ARTHUR STREET SOUTH
W.S.C.C. NO. 244

July 9, 2021

Re: File No.: OZS21-007

2278570 Ontario Inc/5 Arthur St Developments Rezoning Application - 93 Arthur St. South

92 ARTHUR ST. S OFF SITE PARKING

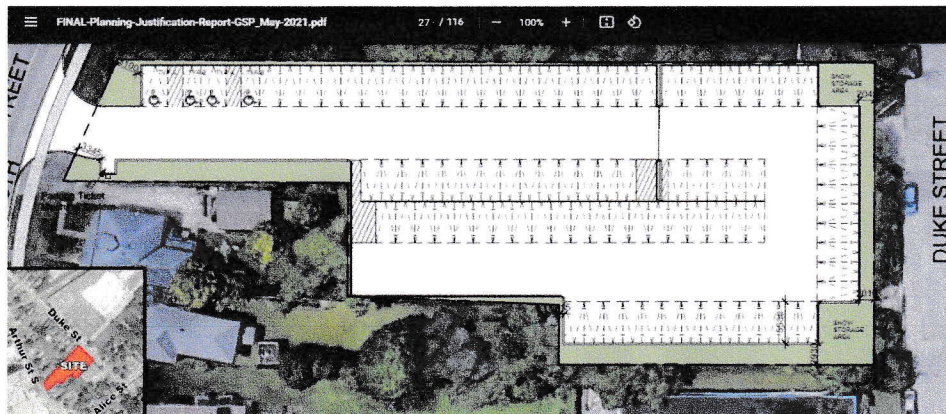
Off site parking (Fig. 2) provides for 94 parking spaces including 4 barrier-free located at 92 Arthur. The Phase 4 development proposes use of 56 residential parking spaces at 92

Arthur. There remaining 38 spots are designated for commercial use of which 10 visitors and 2 commercial spaces are allocated to the 93 Arthur development. With the serious shortage of residential spaces, it is unacceptable for the Applicant to provide 26 commercial spaces at the expense of the 93 Arthur St. Residents and Tenants.
